09.25.23 Response to Request for Information in connection with The Invitation to Bid Construction Services: ITB No. 08-79-05624, Historical Museum of South Padre Renovation Project.

ADDENDUM NO. 1

PROJECT: Invitation to Bid Construction Services: ITB No. 08-79-05624 Historical Museum of South Padre Renovation Project

2.1

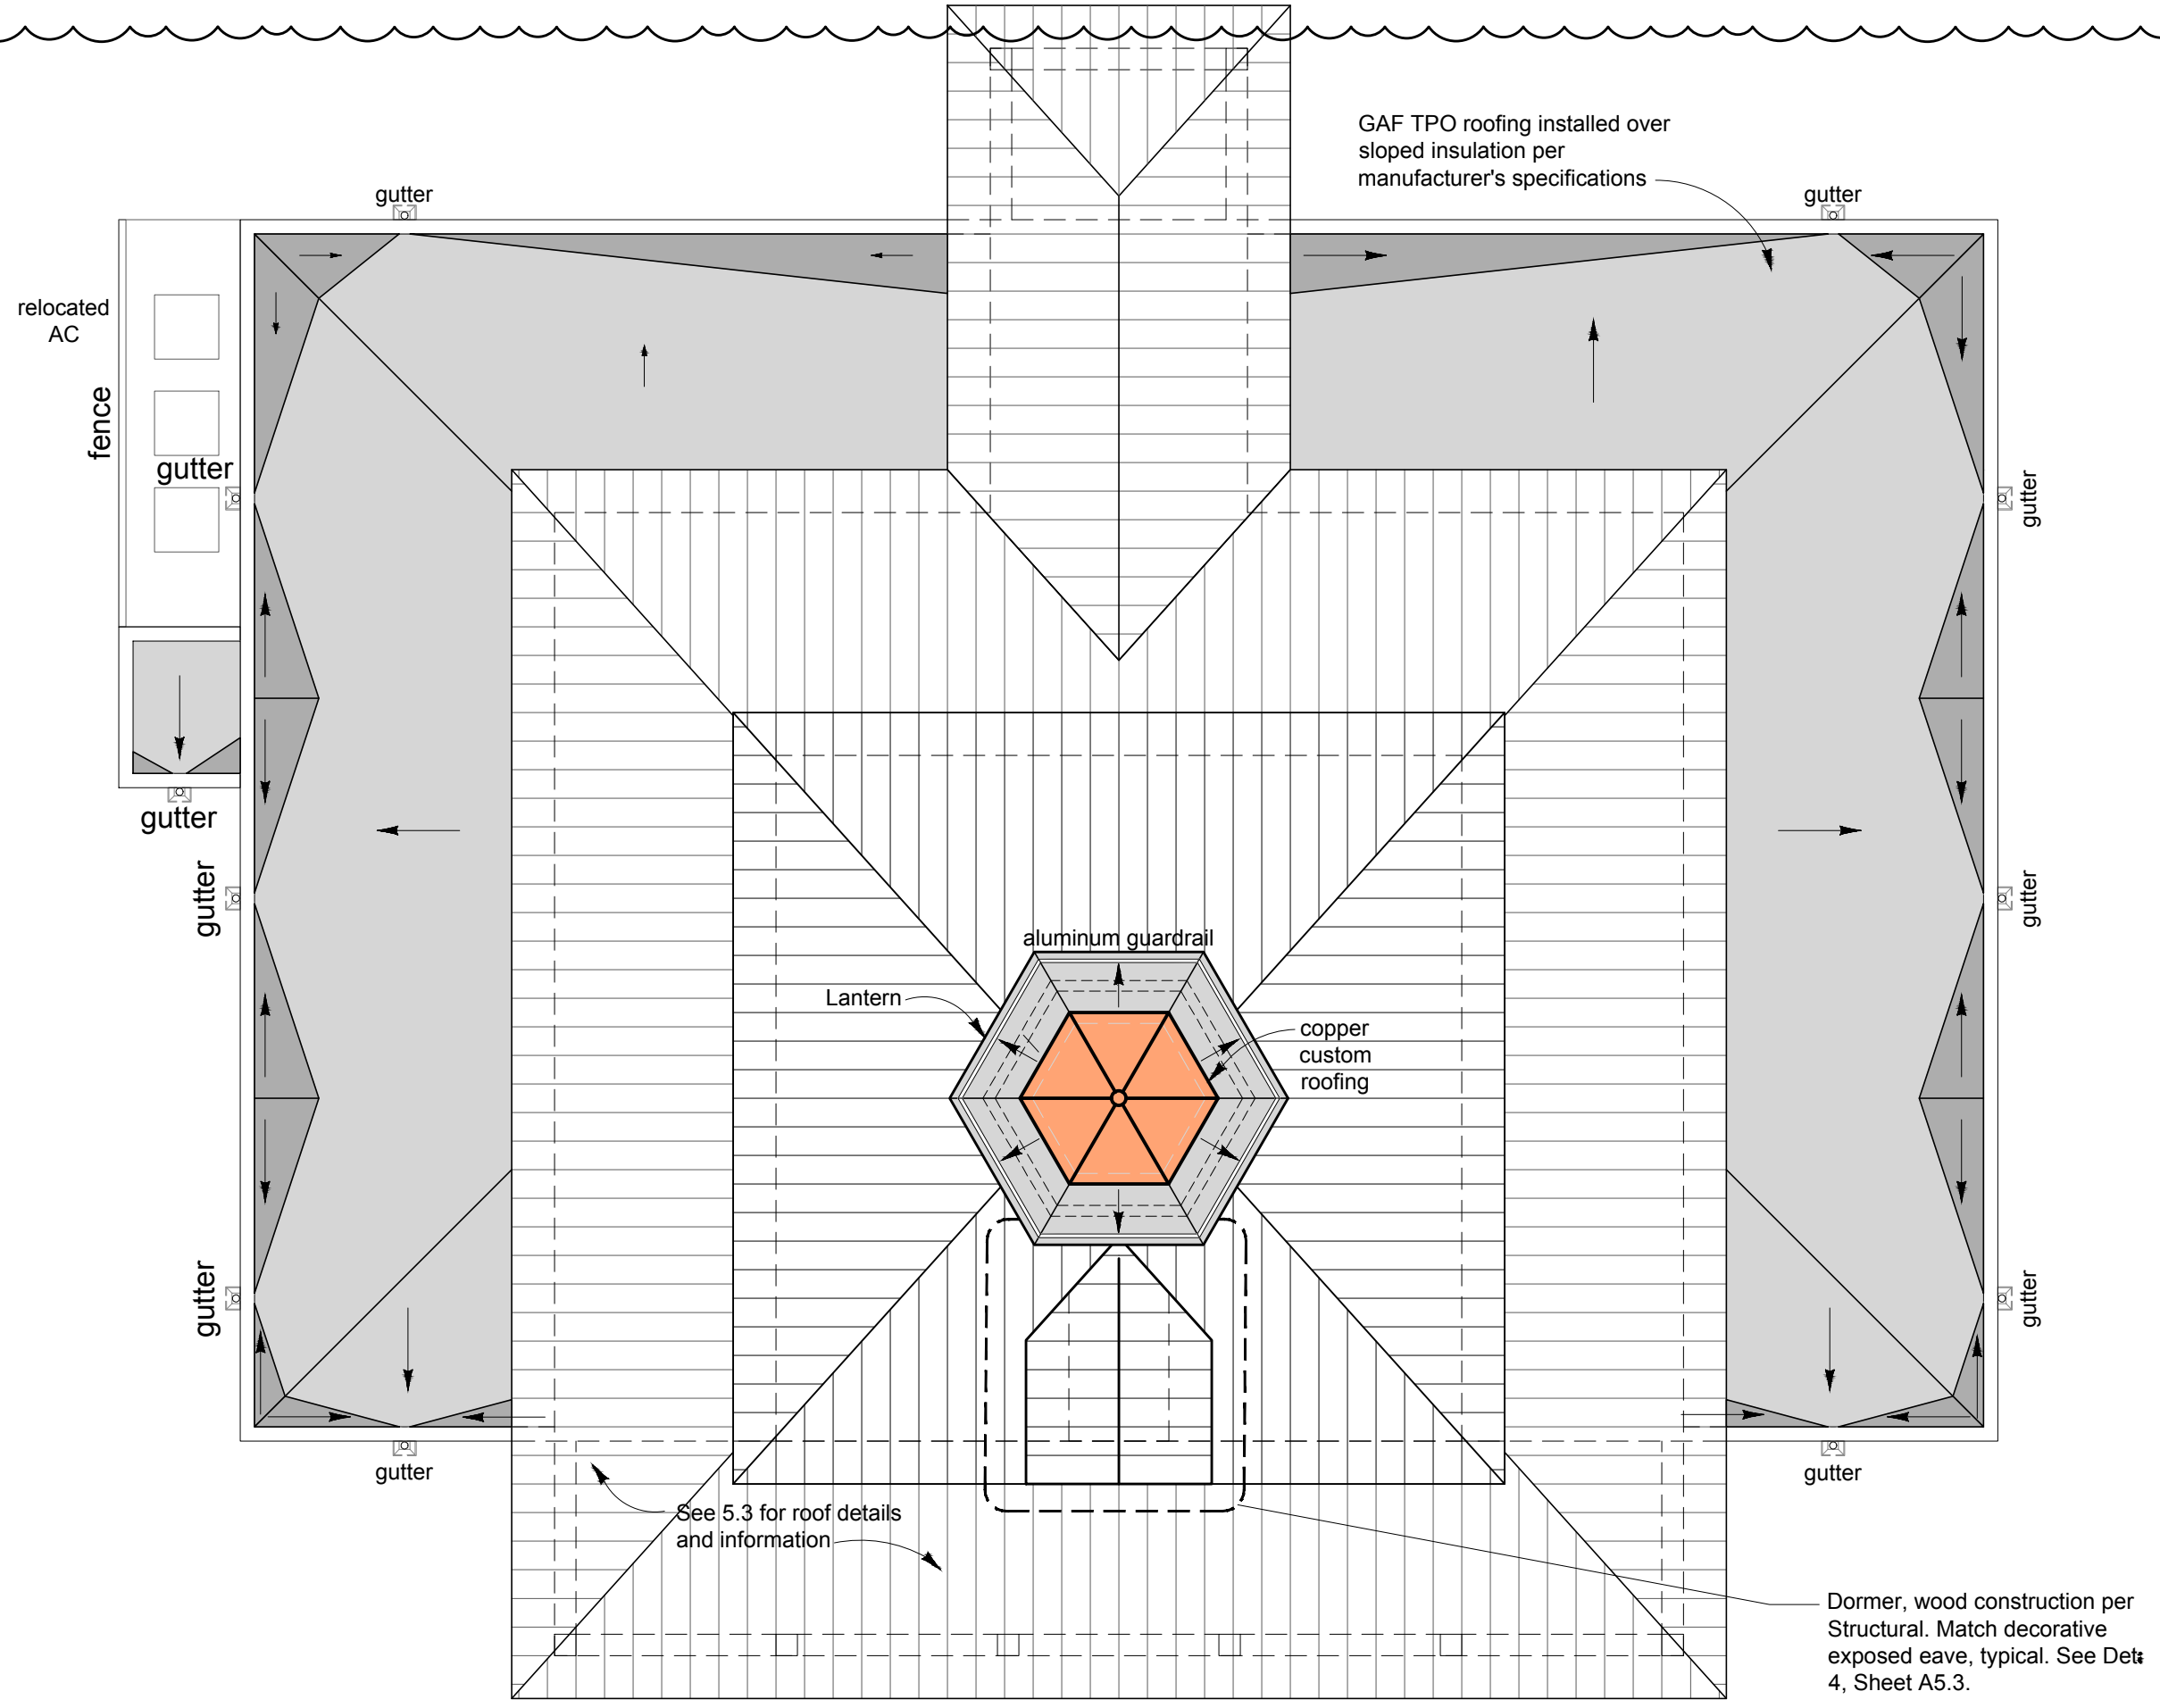
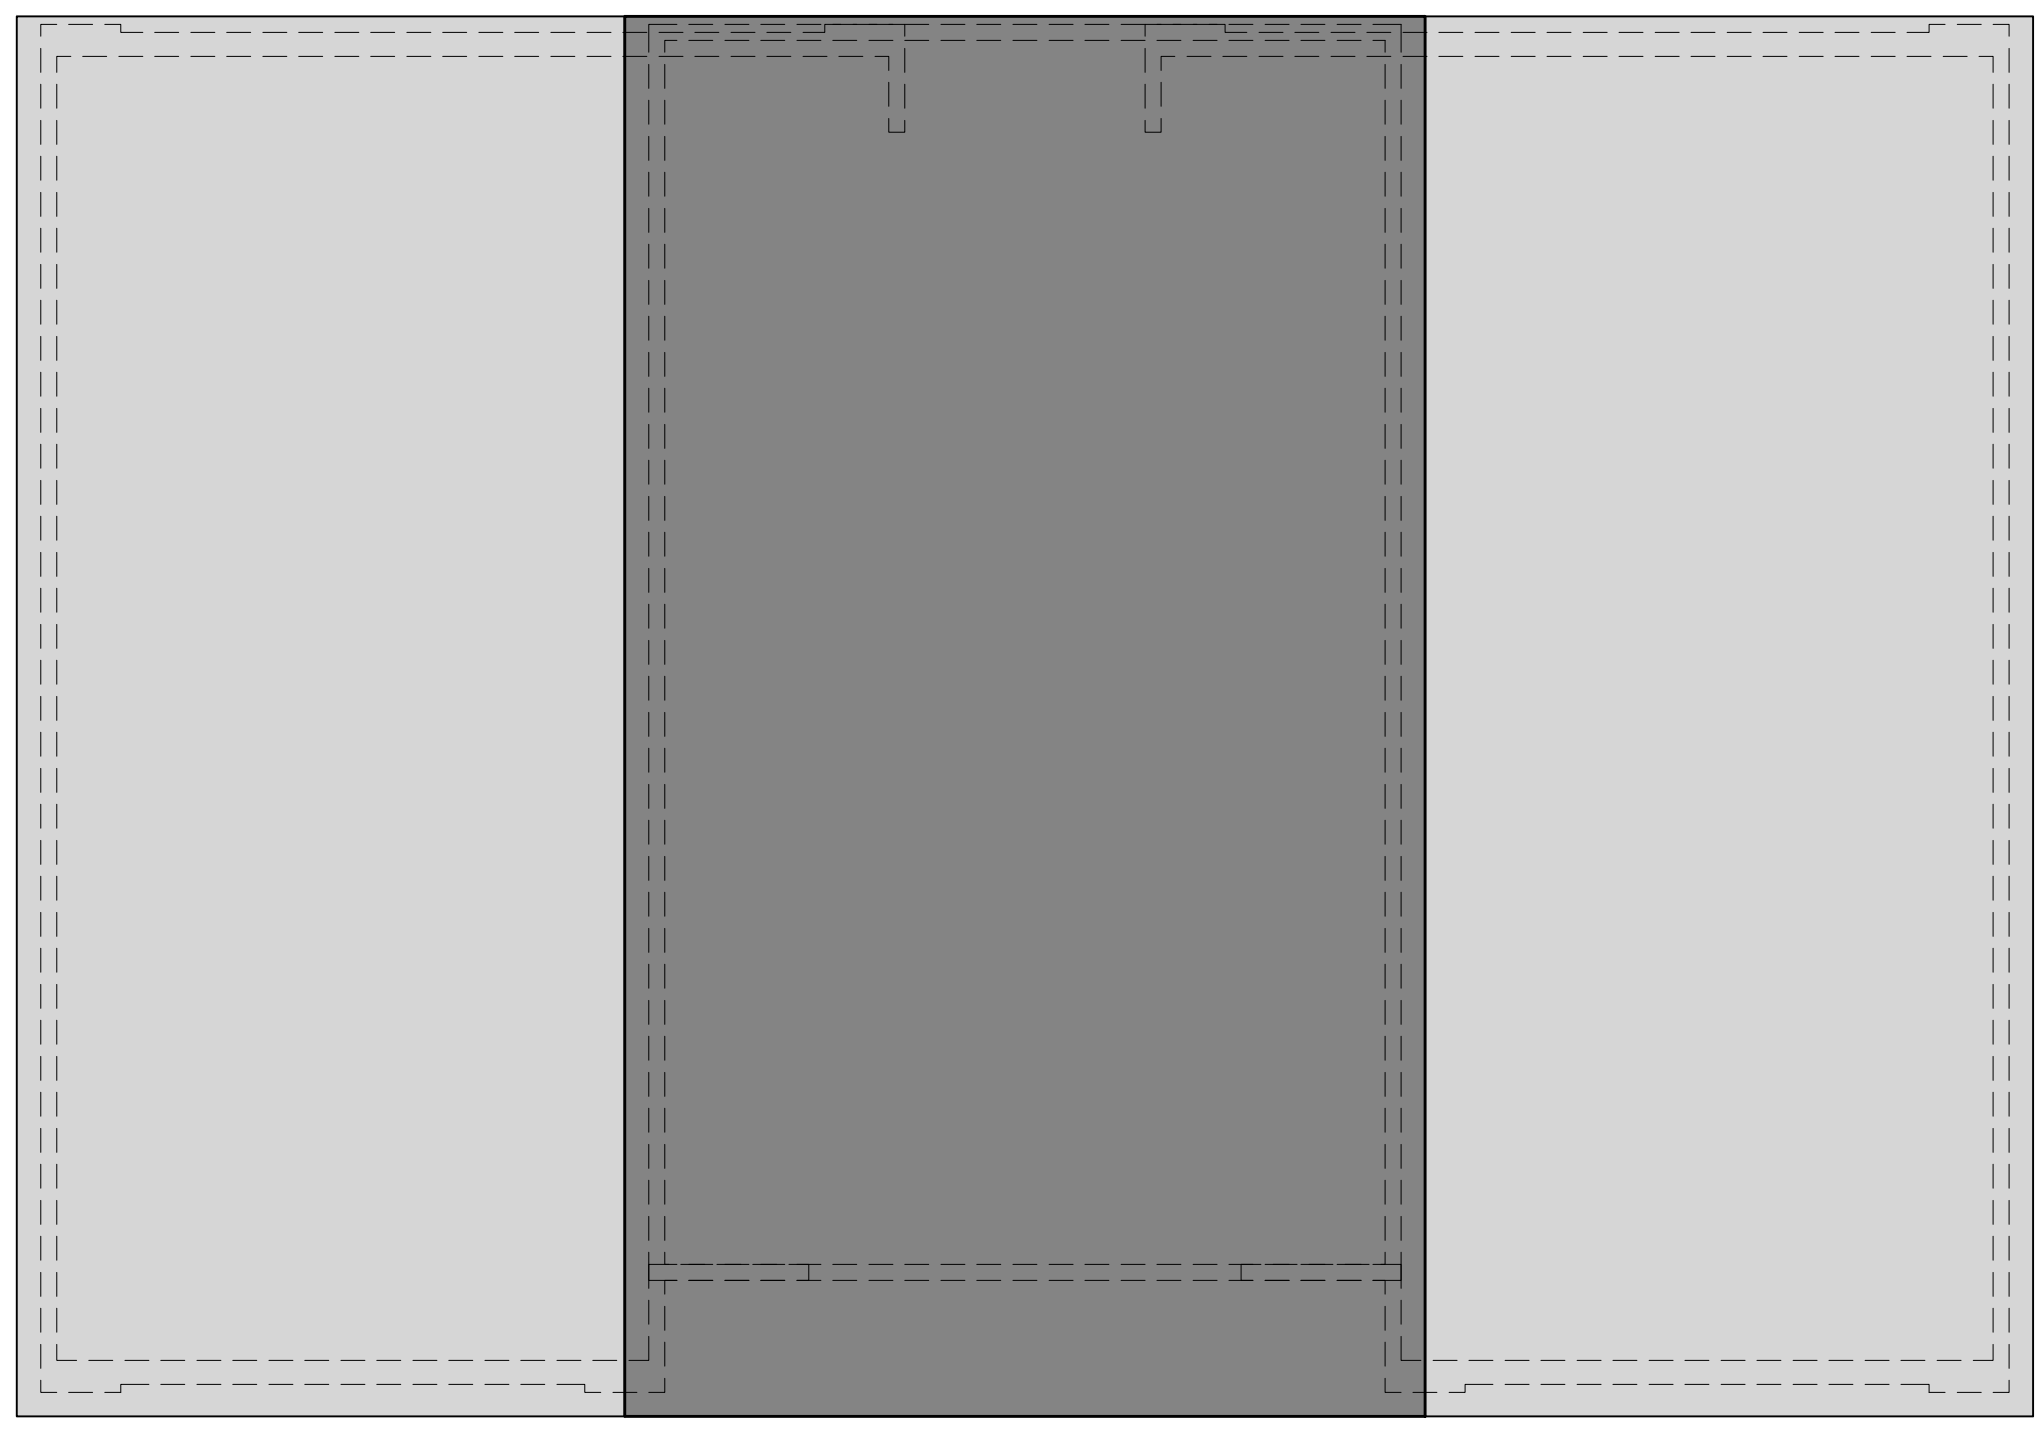
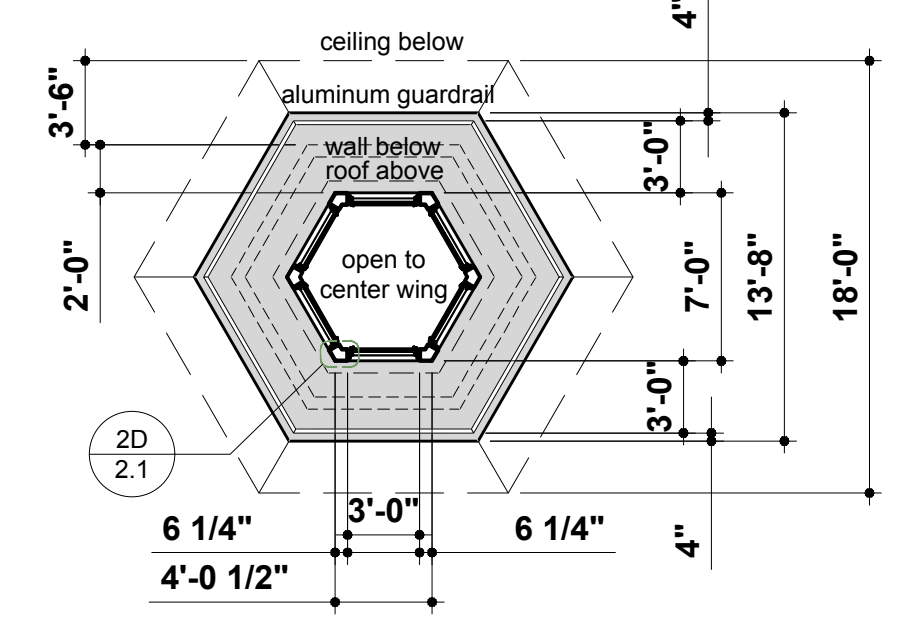
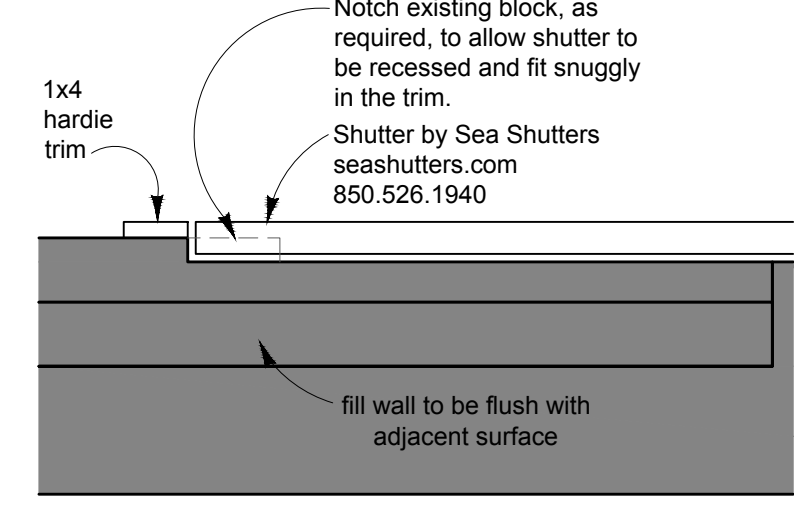
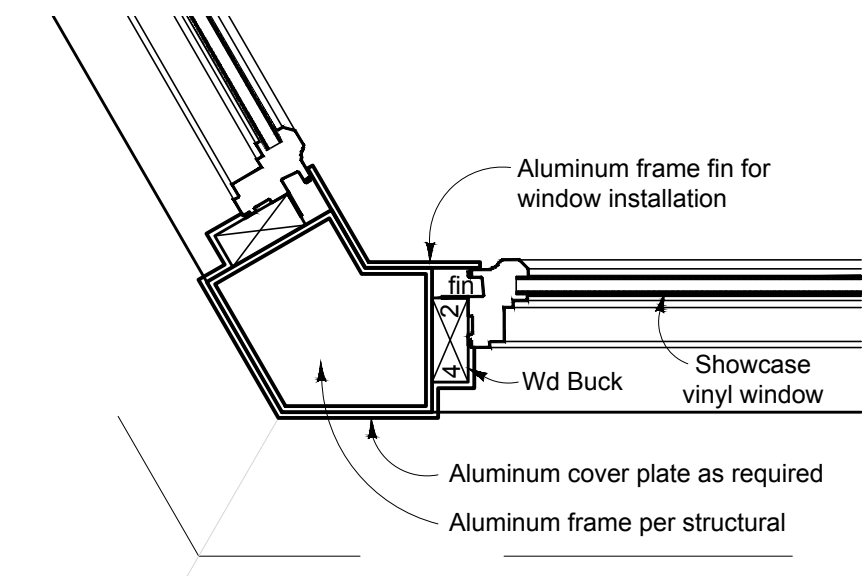
1. Interior Finishes Clarification:
Refer to updated Plan Sheet 2.1, dated 09.13.23, attached hereto:
 - a. All walls shall be gyp-board level 4 painted.
 - b. All floors shall be Anatolia Porcelain Tile, Aspen Collection, Paper Birch color (8"x48").
 - c. The bases shall be 1"x 8" painted high gloss oil-based paint.
 4. The ceilings shall be 6" polar v groove, tongue and groove finish, pickled-wash and gyp bd., per the Ceiling Plan Sheet 9.1.
